PD Modification Application:

PRS 23-0382

BOCC Land Use Meeting Date:
January 9, 2024

The requested change is to:
(1) Shift the location of the emergency access ~~east~~ southward to allow full access from Jackson Springs Rd. to the adjacent RSC-6 property only. **The emergency-only access will remain for the PD use.**

2.5 Proposed Site Plan

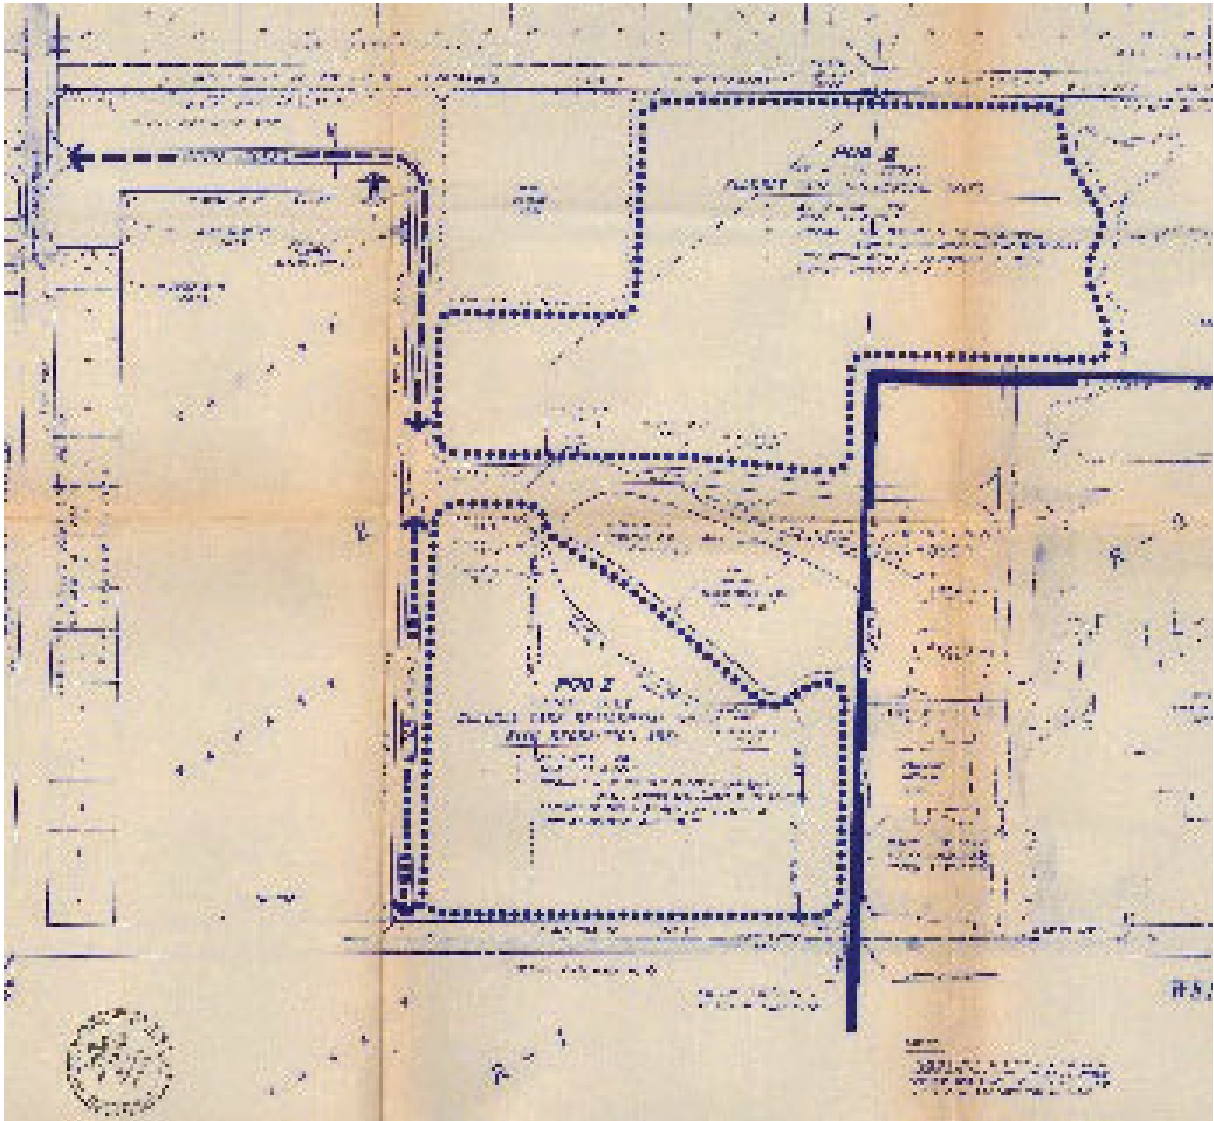
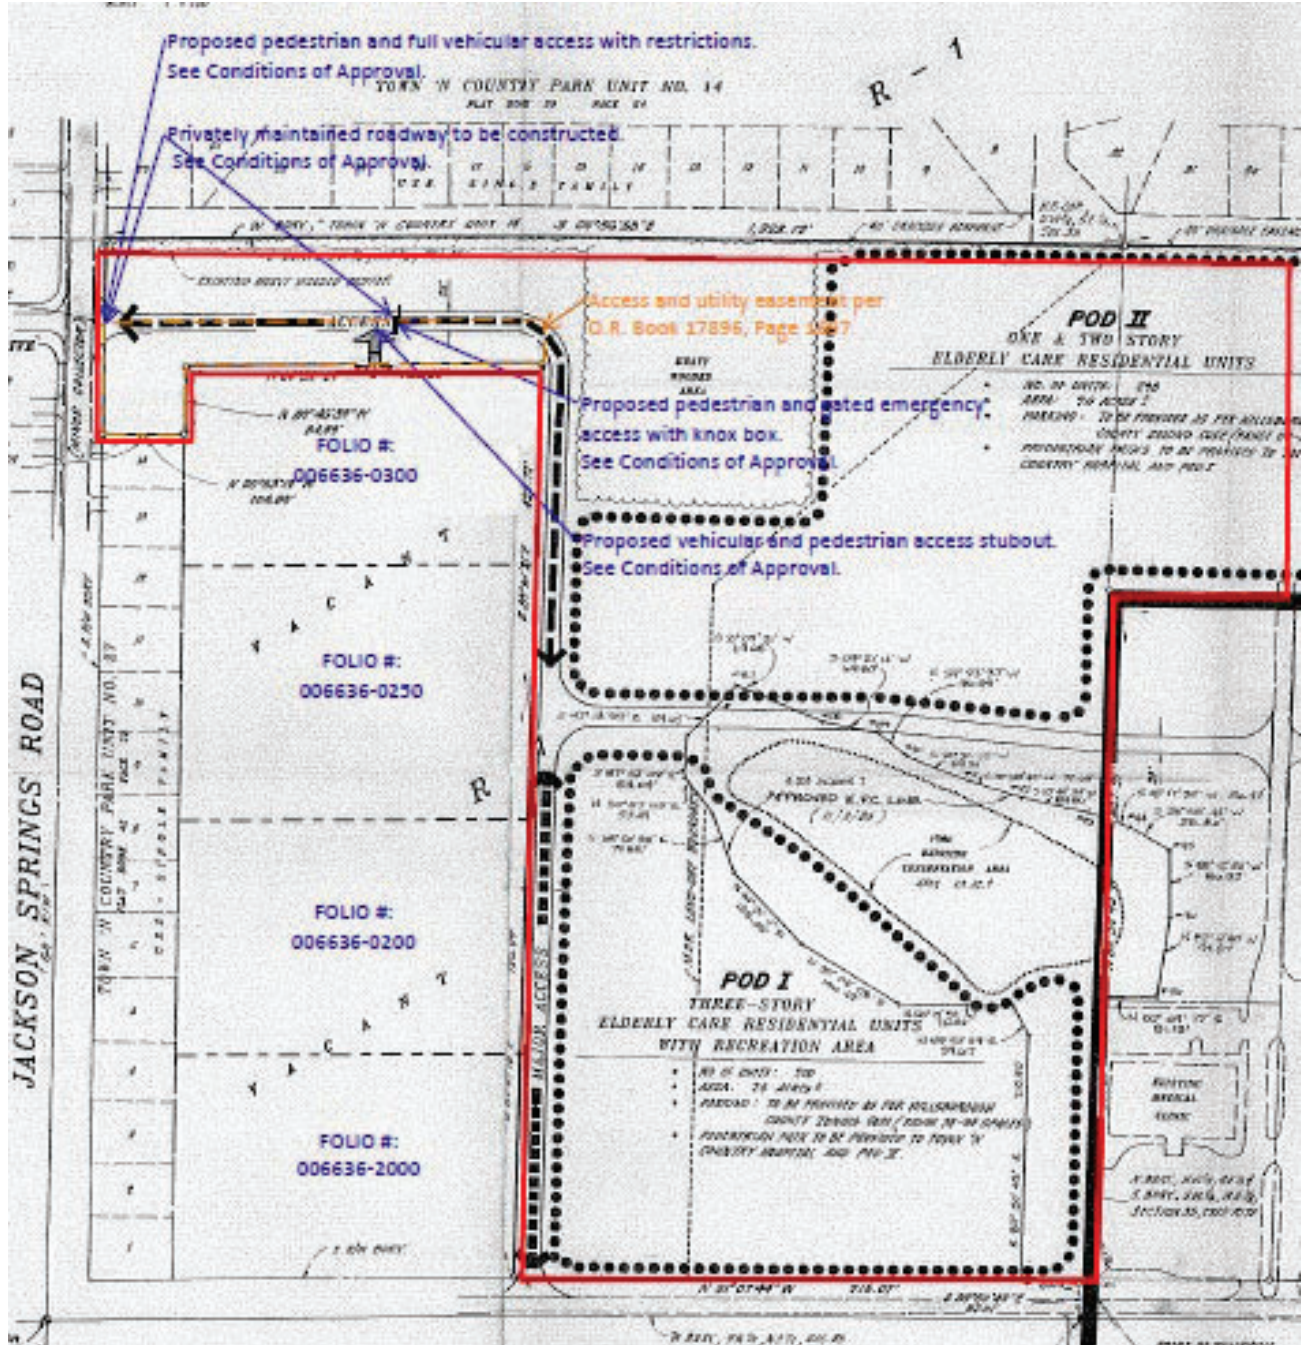
The existing PD is restricted to emergency only access to Jackson Springs Rd. According to the applicant's narrative the proposed minor modification proposes to shift the location of the emergency access ~~eastward~~ southward and allow full access from Jackson Springs Road to eliminate the need to "circumvent or disturb any wetland". The primary PD uses are accessed via Webb Rd. The currently application seeks to modify the project to permit an adjacent property (folio 6636.0300) to take access through the subject PD via Jackson Springs Rd.

- a. The developer shall construct a modified TS-7 roadway between Jackson Springs Rd. and the proposed access stubout to and serving folio 6636.0300. Such roadway shall be considered a Shared Access Facility (with folio 6636.0300), shall be privately owned and maintained, and shall be platted in accordance with the standards set forth in Sec. 6.02.01.B.2. of the LDC.

- b. The developer shall also construct a gated emergency access stubout at the southern end of the roadway as generally shown on the PD site plan (to serve the primary PD uses), which shall be gated with a Knox Box or other similar device acceptable to the Hillsborough County Fire Marshall.

EXHIBIT 1 REVISED PD PLAN

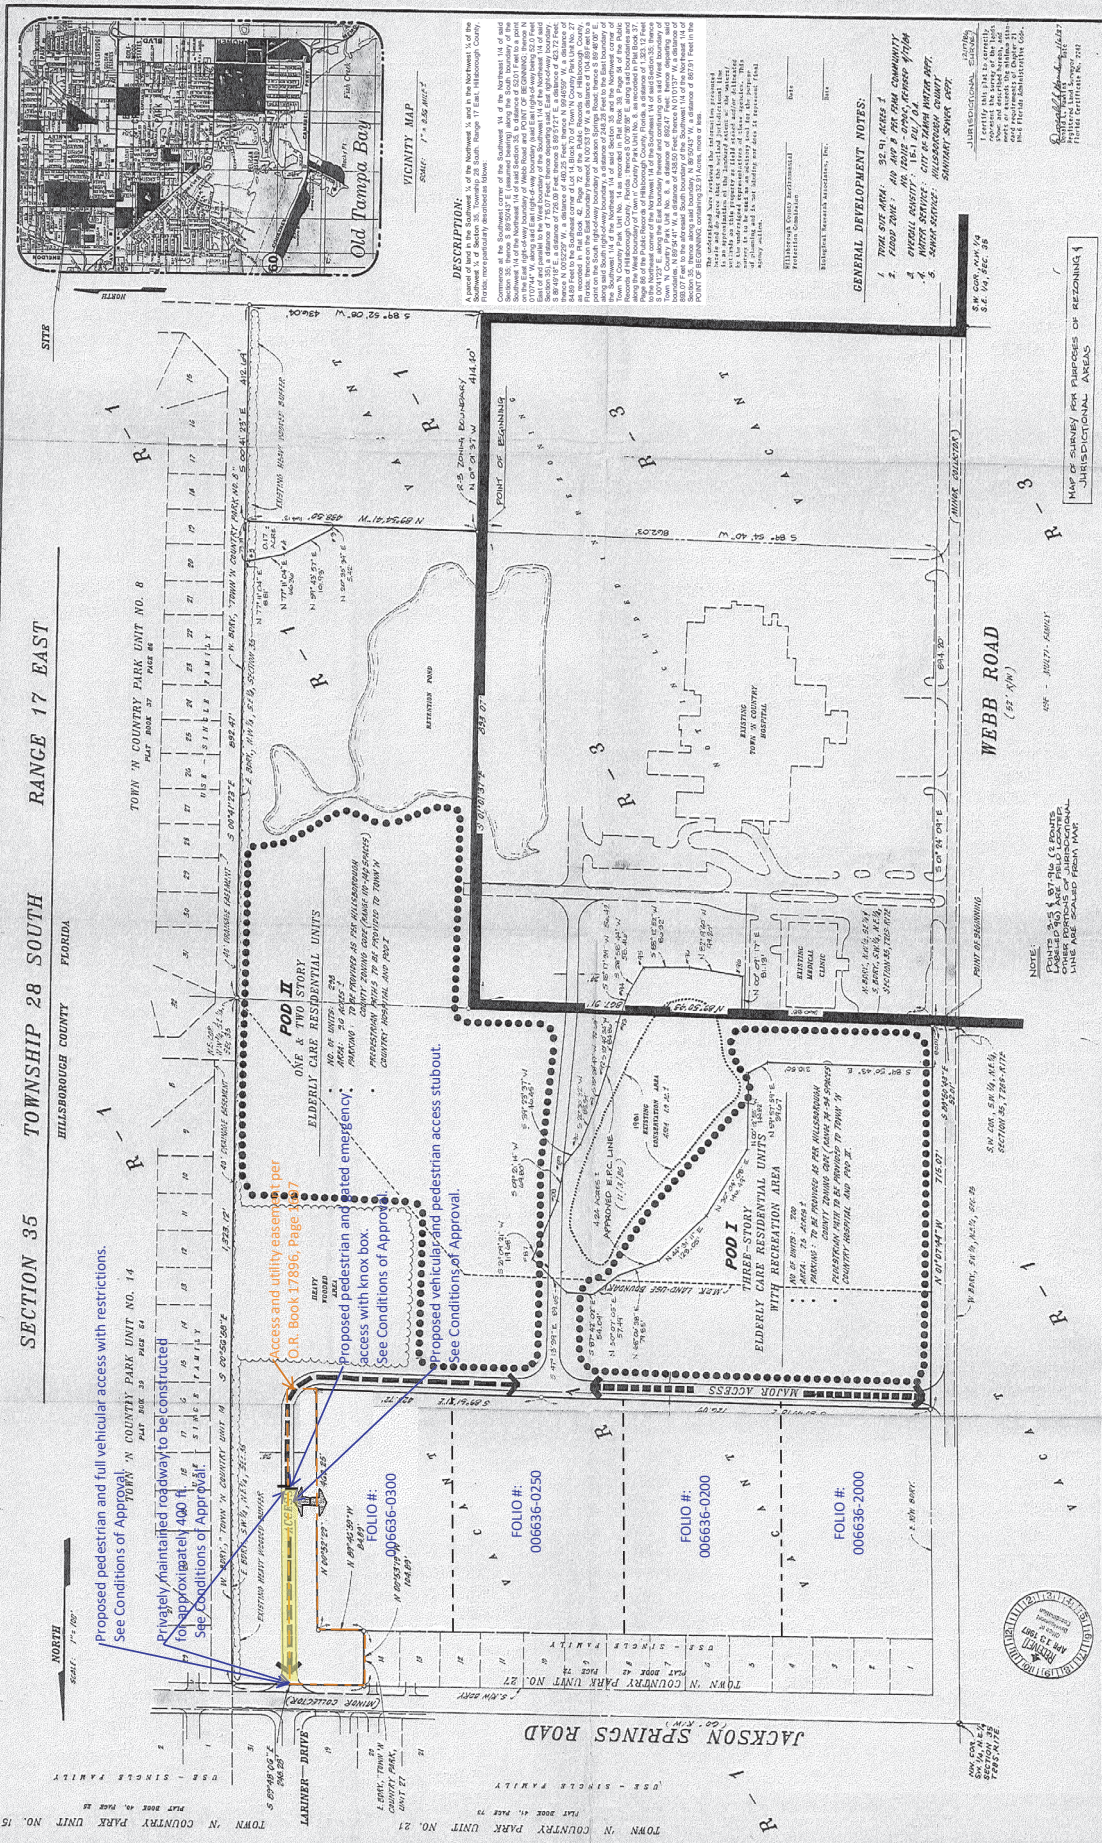
The developer proposes a minor modification to the existing Planned Development (PD) to adjust the emergency ingress and egress access on Jackson Springs Road, as shown on the revised PD Plan in Exhibit 1. The access will be a shared access with a proposed 12-single family residential home community, within Folio Number 006636.0300, located southwest of the shared access point of connection. The shared access will not be a dedicated or plated right-of-way. There is currently a recorded easement for access and utility per O.R. Book 17896, Page 1697 as indicated on the revised PD Plan in Exhibit 1. This shared road will be viable access to said proposed community. The proposed minor modification, if approved, will avoid floodplain impact and wetland impact via direct access on Webb Road. Jackson Springs Road access will certainly avoid impact to the surrounding environmentally sensitive area as shown on aerial map in Exhibit 2.

The proposed 400 ft shared access improvement, as shown on the revised PD Plan in Exhibit 1, will be limited to the aforementioned 12-single family residential home community pedestrian and full vehicular access and the Tampa Community Hospital emergency vehicles only. Currently, there is no access route from the hospital facility to Jackson Springs Road as this road has not been built yet. Tampa Community Hospital may decide to build the rest of the access at a later time. The proposed shared access will be privately maintained TS-7 type of roadway. TS-7 includes the following characteristics:

EDITED TS-7 TYPICAL SECTION

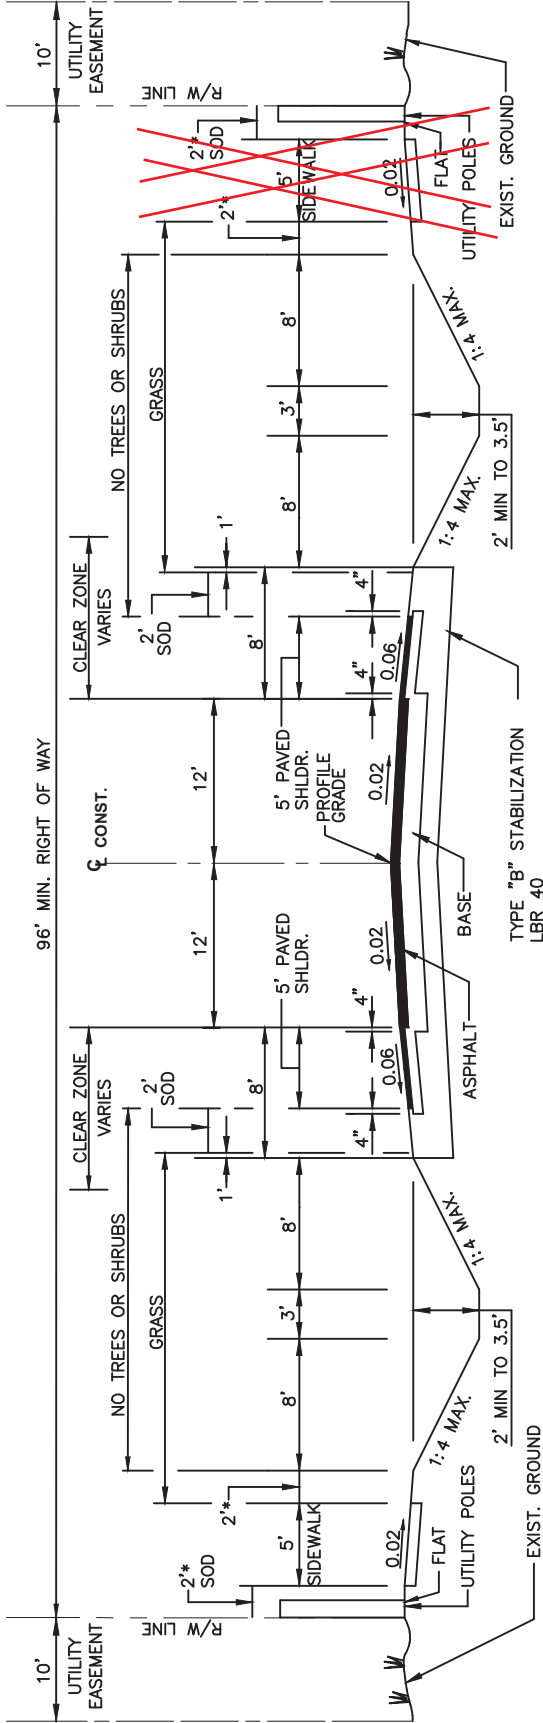
road. Edited TS-7 typical section is attached as Exhibit 3. We believe this design exception is appropriate because the pedestrian traffic will be limited to the 12-single family residential home community only. This will avoid pedestrian crossings on a road that will eventually be shared with the Tampa Community Hospital emergency vehicles. Additionally, no development exists or is planned east of the shared access road. The west (south bound) sidewalk will be constructed from the north side of the proposed community entrance to tie to the existing sidewalk on Jackson Springs Road.

- c. The modified TS-7 roadway shall be constructed consistent with the Design Exception referenced in condition 20 hereinbelow (i.e. the developer shall construct the roadway to the TS-7 standard, except that a sidewalk shall not be required along the eastern side of the proposed roadway).

EDITED TS-7 TYPICAL SECTION

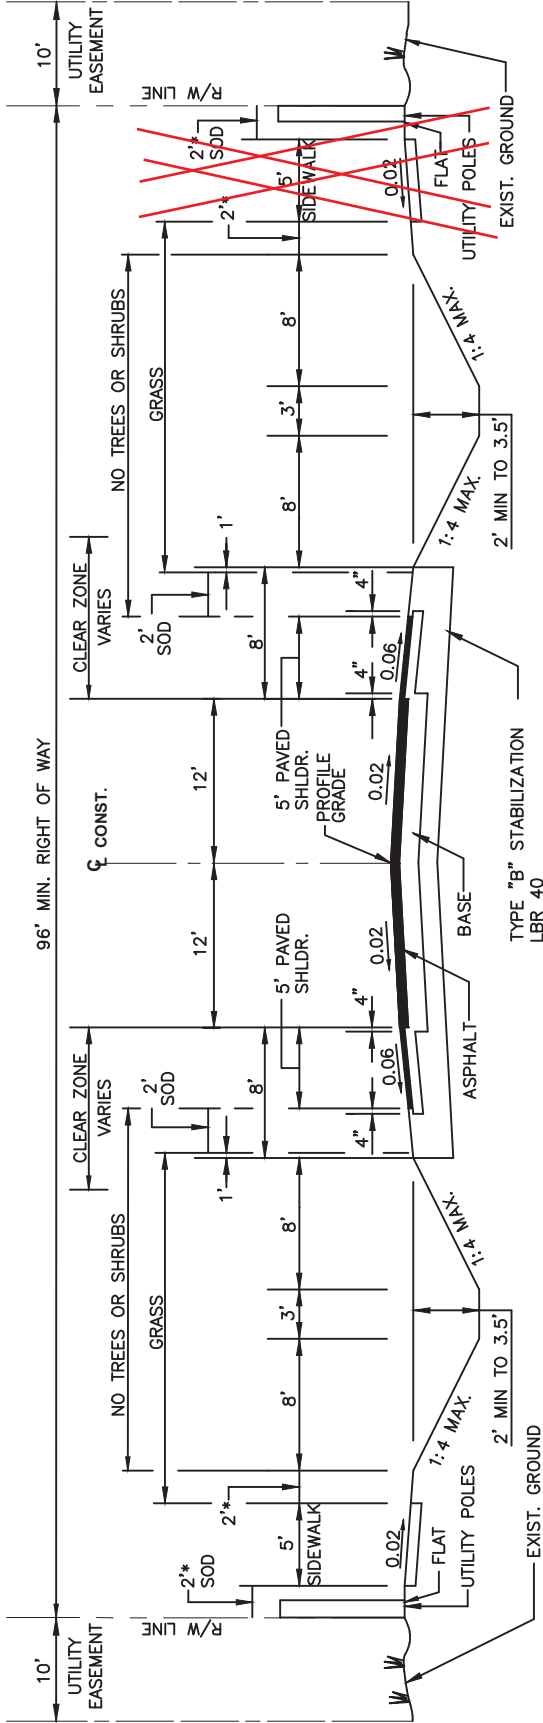
road. Edited TS-7 typical section is attached as Exhibit 3. We believe this design exception is appropriate because the pedestrian traffic will be limited to the 12-single family residential home community only. This will avoid pedestrian crossings on a road that will eventually be shared with the Tampa Community Hospital emergency vehicles. Additionally, no development exists or is planned east of the shared access road. The west (south bound) sidewalk will be constructed from the north side of the proposed community entrance to tie to the existing sidewalk on Jackson Springs Road.

- c. The modified TS-7 roadway shall be constructed consistent with the Design Exception referenced in condition (zoning staff to insert new condition number) hereinbelow (i.e. the developer shall construct the roadway to the TS-7 standard, except that a sidewalk shall not be required along the eastern side of the proposed roadway).
